# Rezoning Transportation Analysis

Petition Number: 2026-011

General Location Identifier: 05109134

Date	Description
03-26-26	First Review (BH)
04-23-26	Second Review (BH)

~~6+ Boulevard with Shared Used Path (Charlotte Streets Map)~~

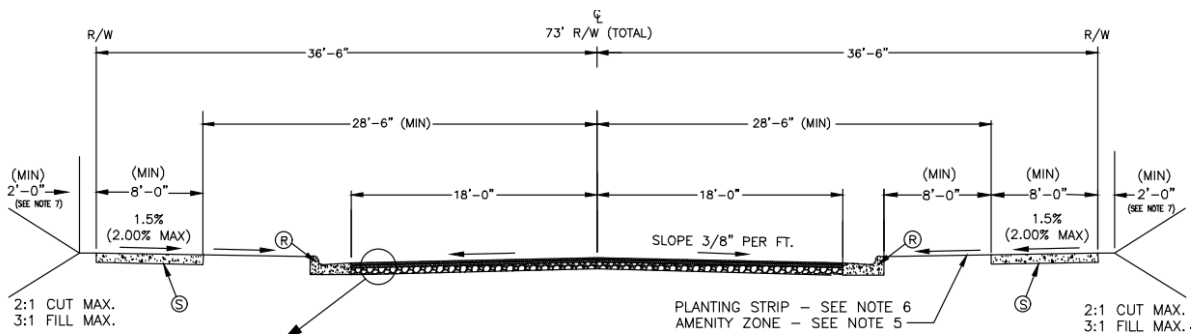
- a. ~~**N Tryon St:** Location of future back of curb and gutter is to be shown at 44 feet from road centerline and must be shown in the future location according to UDO Article 32.7.~~

~~Label and dimension the existing and future curb and gutter from the centerline for each road on the site plan.~~

~~Local Office/Commercial Wide with 8' Sidewalk (CLDSM)~~

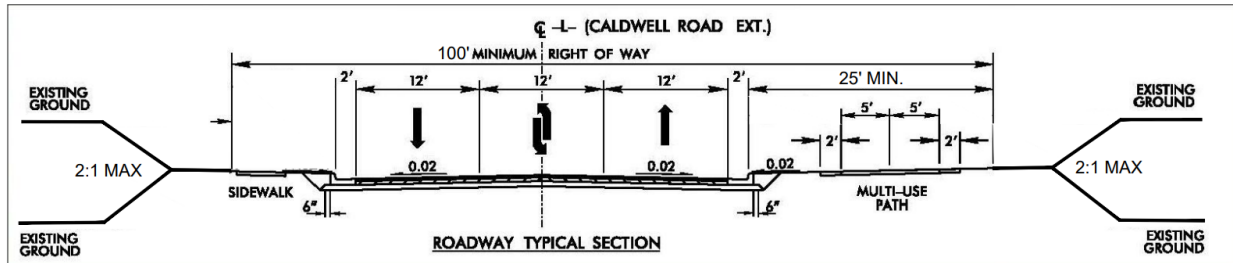
- b. ~~**Lempira Ln:** Location of future back of curb and gutter is to be shown at 20.5 feet from road centerline and must be shown in the future location according to UDO Article 33.3 and Charlotte Land Development Standards Manual (CLDSM) in coordination with subdivision and CDOT.~~

~~Label and dimension the existing and future curb and gutter from the centerline for each road on the site plan.~~

## PROPOSED CALDWELL ROAD EXTENSION SECTION

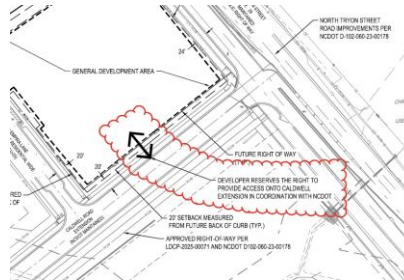
- c. ~~Caldwell Road Extension: Location of back of curb and gutter is to be shown according to approved project (Accela Project # LDCP-2025-00071/RZP-2021-150).~~

~~Future state-maintained major thoroughfare.~~

~~Label and dimension the curb and gutter from the centerline for each road on the site plan.~~
